DS #: 4979

PROJECT: Floor 5 Decor

CITY OF LAS VEGAS INTER-OFFICE MEMORANDUM		DATE: June 5, 2018
TO: Land Development Services Department of Building & Safety		FROM: Jennifer Shinn Flood Control Engr. Associate Department of Public Works
SUBJECT:	Drainage Study for: Floor & Decor	COPIES TO: CenterPoint Engineering, LLC
Cross Streets:	SWC of Rainbow Blvd. and Cheyenne Ave.	Floor & Decor
File Number:	F:\Depot\DSMemos\DS4979B.doc	Bart Anderson, P.E., DevCo
Parcel Number:	138-15-502-006	
Zoning Action:	SUP-72991	
FEMA Flood Zone	YES NO X	
Proposed Storm Drain	YES NO X

RE: DS4979
Floor & Decor
Drainage Study Resubmittal

SHEET NO. **C6.0**

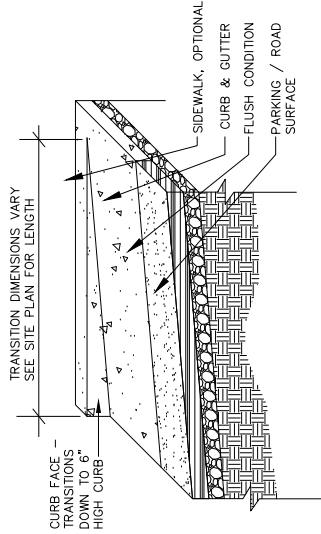
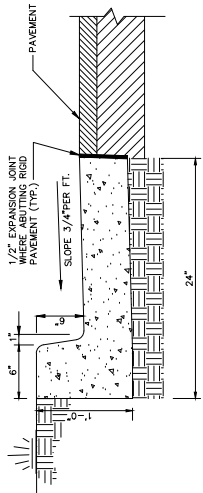
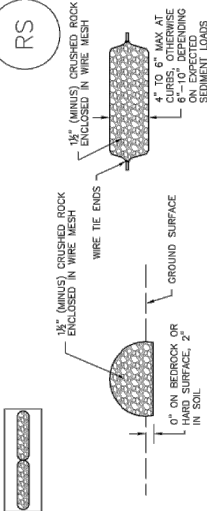
5. Add construction notes to the grading plan to clarify what improvements are to be constructed. Include type of curbs, valley gutters, pavement, etc. Include references to standard plans or provide details.

Proposed construction has been noted with specific call-outs on the Grading Plans, Sheet C4.0 and C4.1. Detail Sheet, C6.0, includes specific details for each item.

SHEET NO. **C4.1**

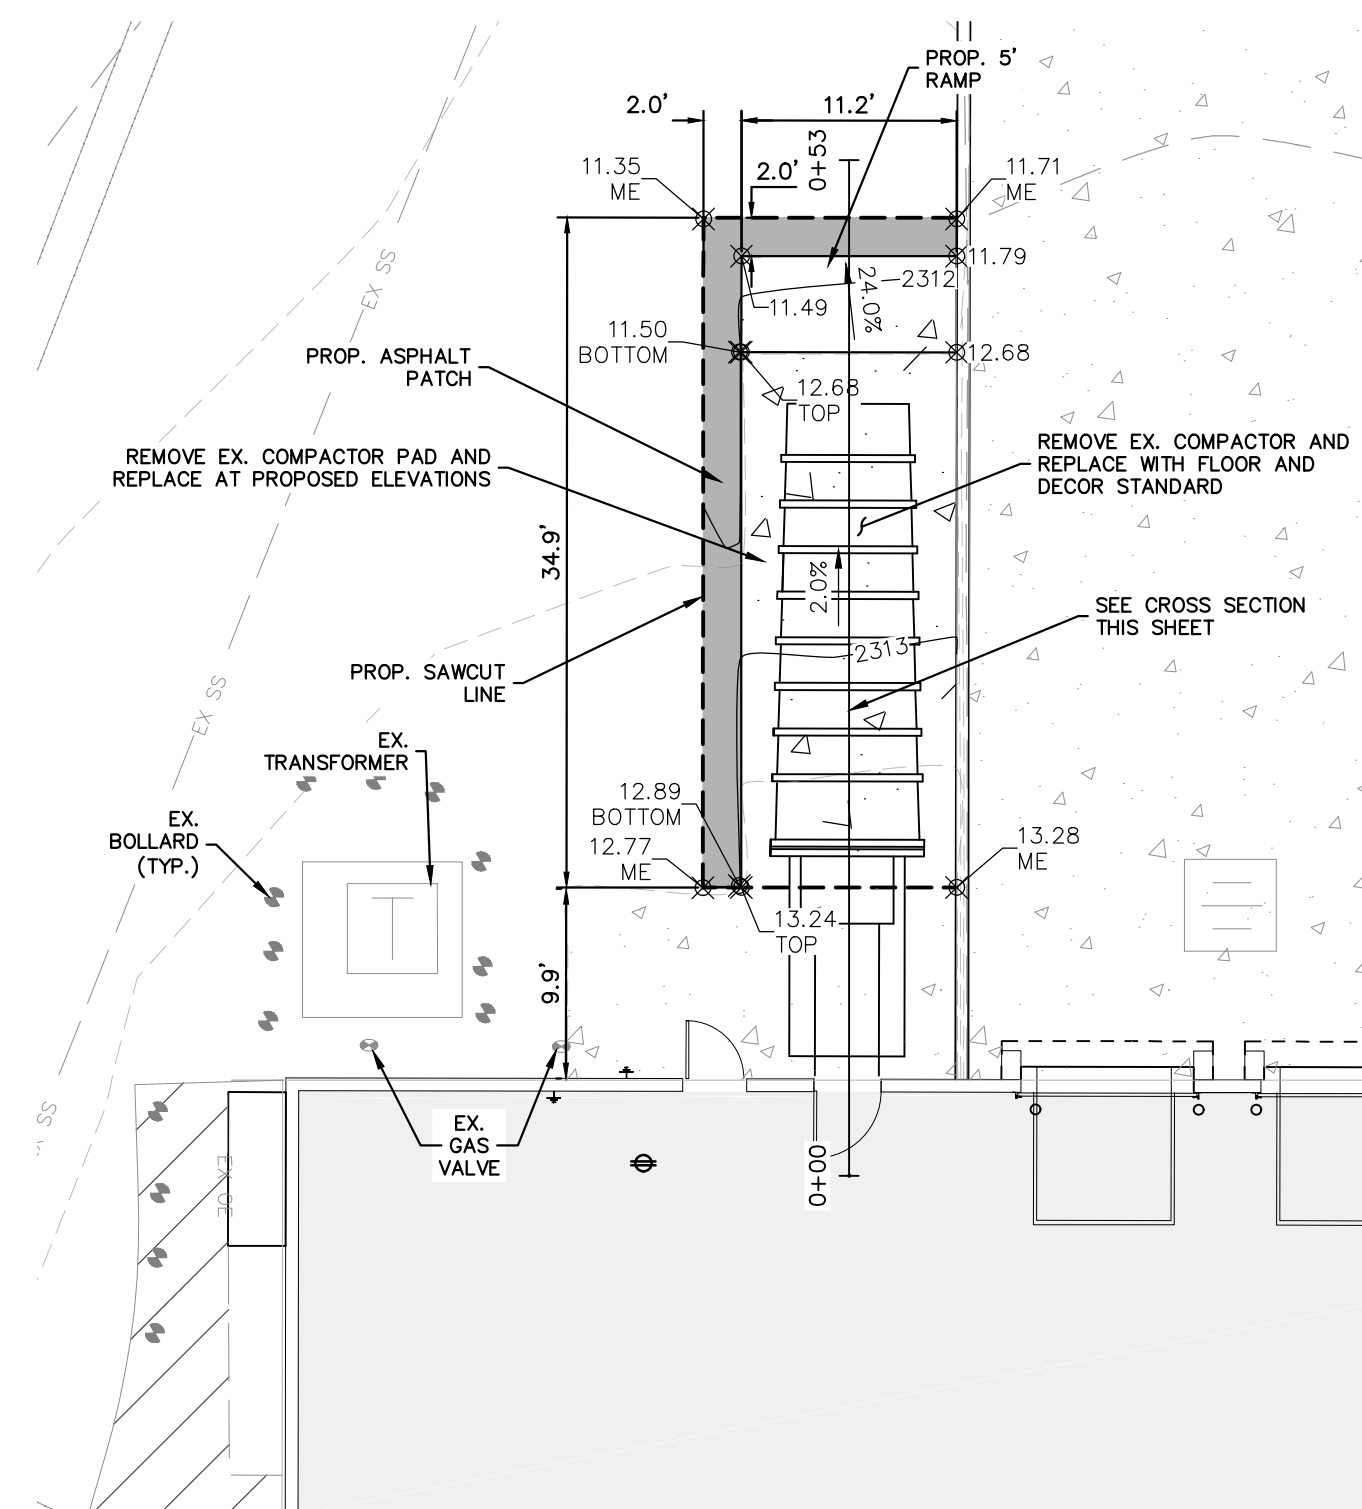
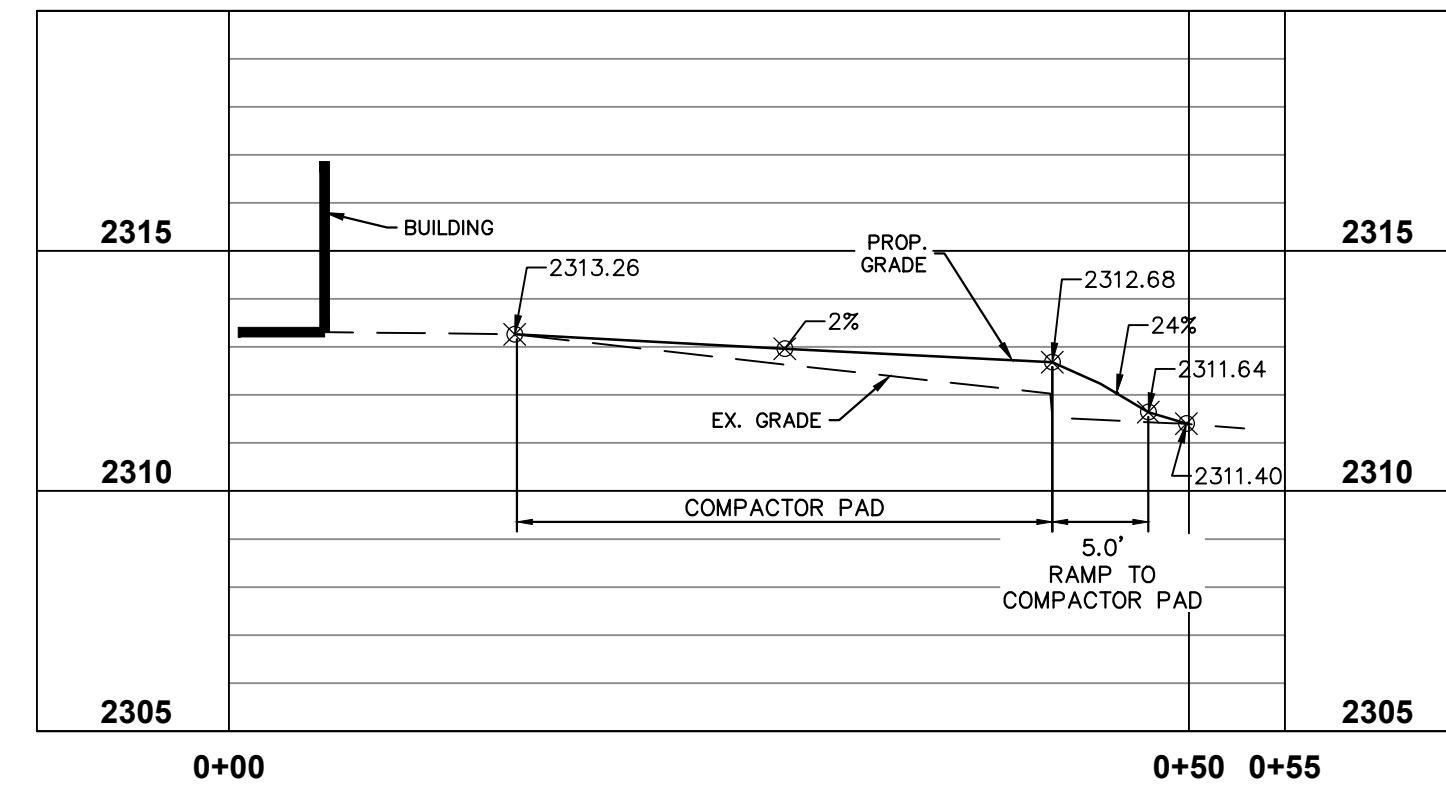
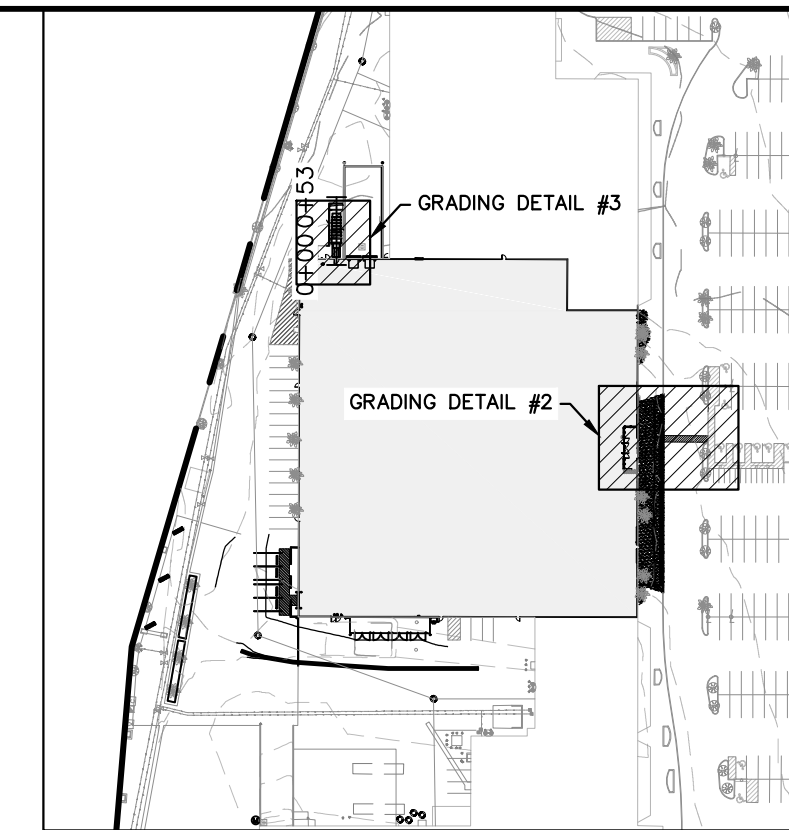
4. Provide the standard drainage compliance note on the grading plan: "I CERTIFY THAT THIS GRADING PLAN IS IN CONFORMANCE WITH THE APPROVED DRAINAGE STUDY ON FILE AT THE CITY OF LAS VEGAS FOR THIS PROJECT (DS4979)."

6. Provide a section detail of the raised trash compactor pad.

The note has been added to the Grading Plans, Sheet C4.0 and Sheet C4.1.

A section detail of the raised trash compactor pad has been added to the Grading Plan, Sheet C4.1.
